ADDENDUM NO. 1 (Final)

WSI: DEEP WELL

MCINTOSH COUNTY INDUSTRIAL DEVELOPMENT AUTHORITY, GEORGIA

DATE: FEBRUARY 26, 2026

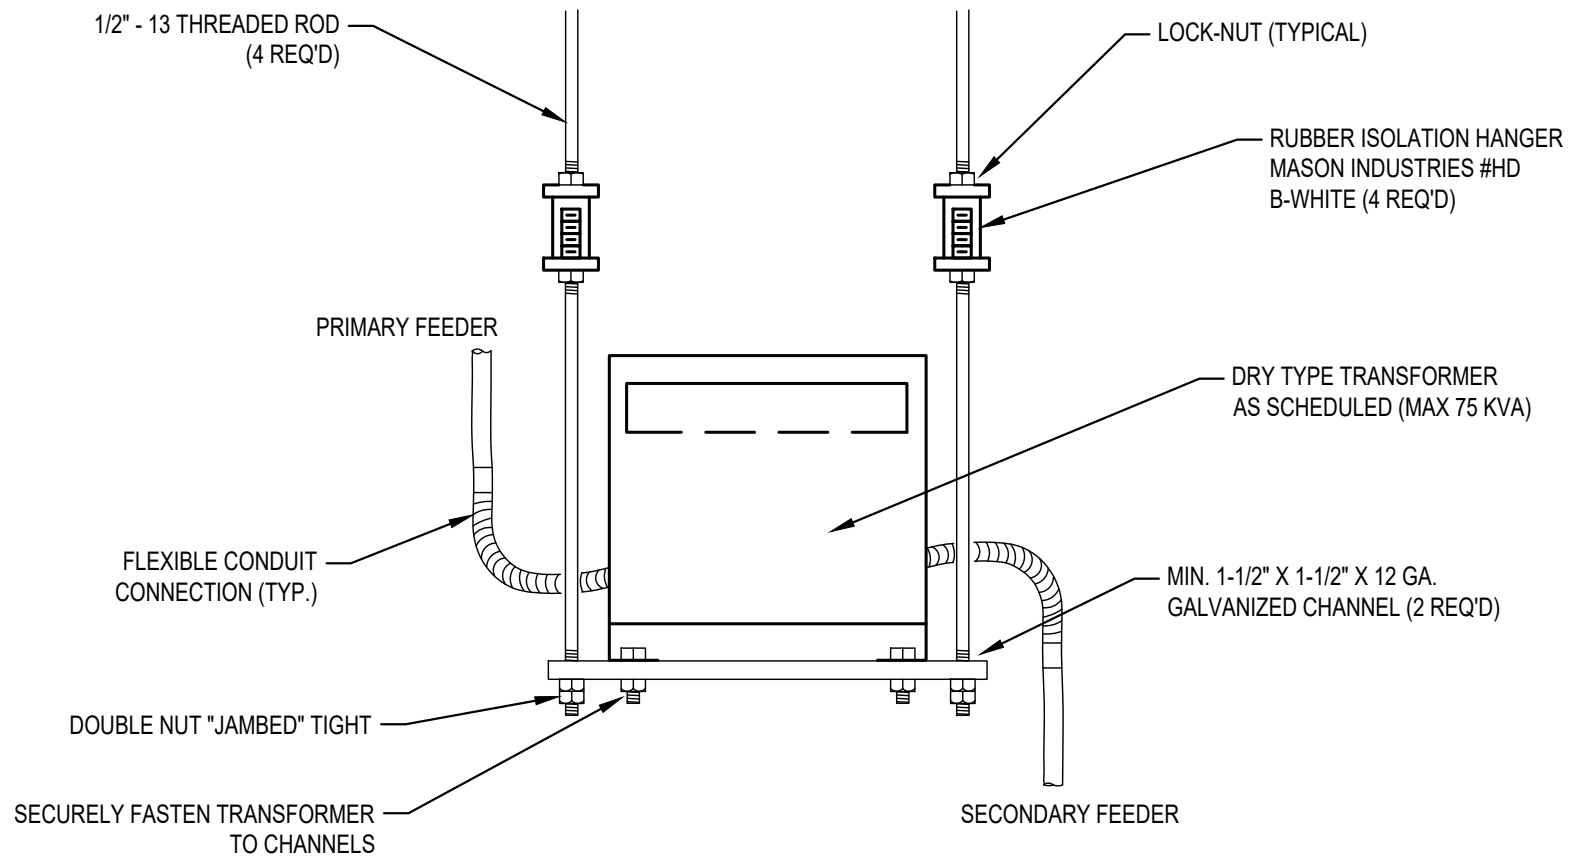
a. Specification Section 01150 (Measurement and Payment) shall be amended, as follows:

i. Insert “*ITEM NO. 3099 – GENERAL CONTINGENCY ALLOWANCE*”

ITEM NO. 3099 – GENERAL CONTINGENCY ALLOWANCE:

This allowance is solely for the use of the Engineer and Owner to cover any unforeseen contingencies which may arise.
